POWER PLANT - ENGINE - INCORPORATE A FUMESAL BRACKET TO PROVIDE ADDITIONAL STRENGTH -
4 - MOD.ENG-71-0052

V2500-ENG-71-0052

SERVICE BULLETIN

Fumeseal Installation on the Bifurcation Panel
Fig.1 Sheet 1 of 2

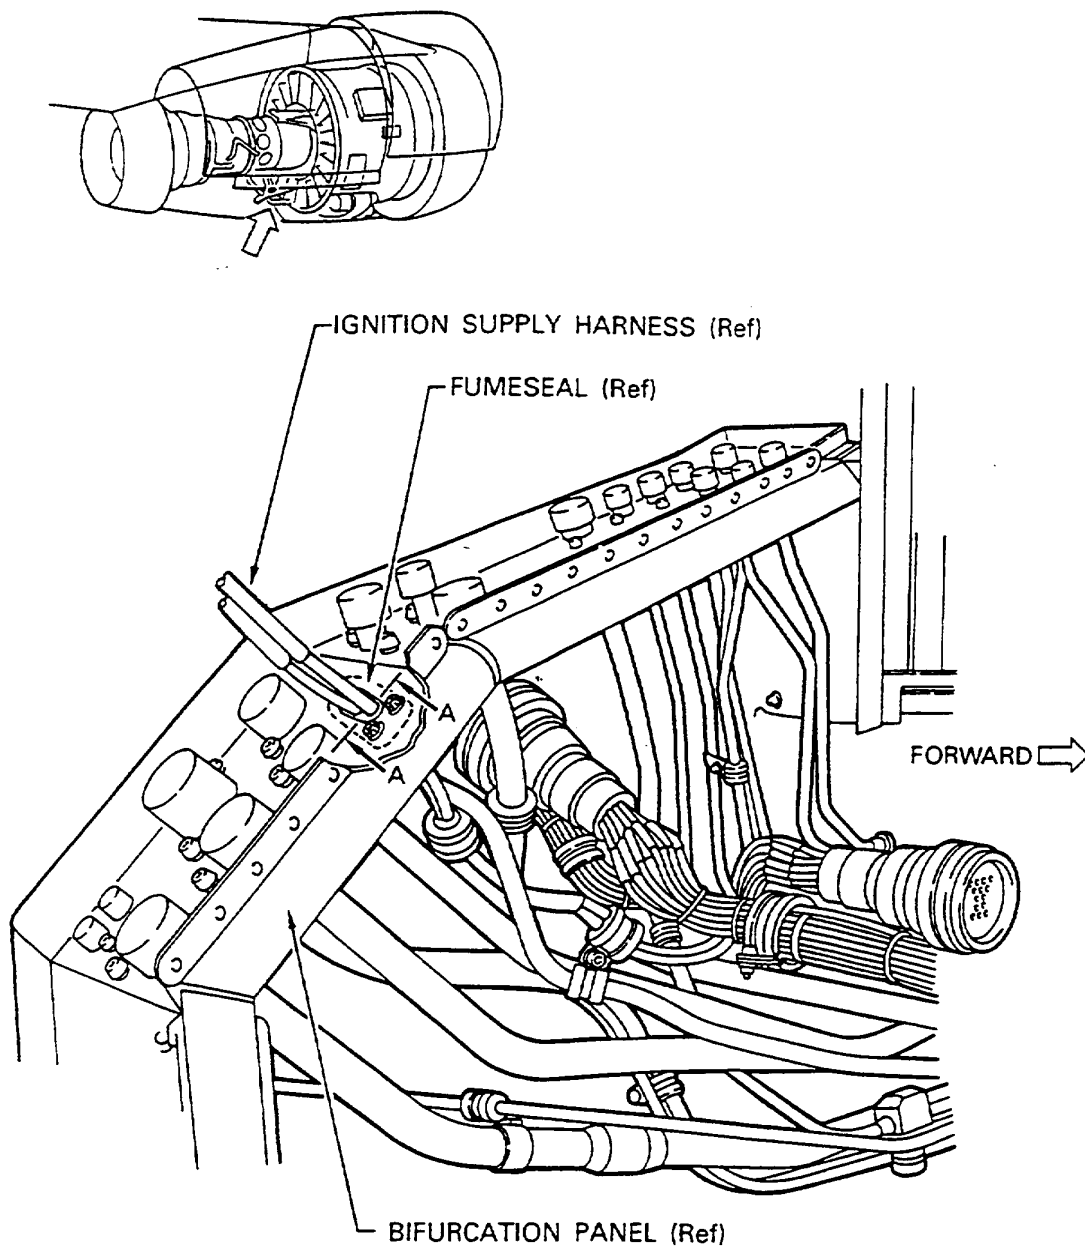
- (a) Additional Fumeseal Brackets are installed to the Bifurcation Panel to increase strength for the installation of Fumeseal in the Bifurcation Panel (See Figure 1).

- (1) Remove the four 4W0001, Nuts, and the four 4W0104, Bolts from the Fumeseal and the Bifurcation Panel. (Refer to Figure 1).
- (2) Install the two additional 5A0368, Fumeseal Brackets to the opposite side of the Fumeseal on the Bifurcation Panel. (Refer to Figure 1).
- (3) Install the four 4W0104, and the four 4W0001, Nuts, to the two 5A0368, Fumeseal Brackets, and the Fumeseal on the Bifurcation Panel. (Refer to Figure 1).
- (4) Tighten the four 4W0001, Nuts on the four 4W0104, Bolts with a torque of 36 - 40 lbfin (4,07 - 4,52 Nm). (Refer to Figure 1, and Aircraft Maintenance Manual, 70-23-11, Torque Tightening Technique).
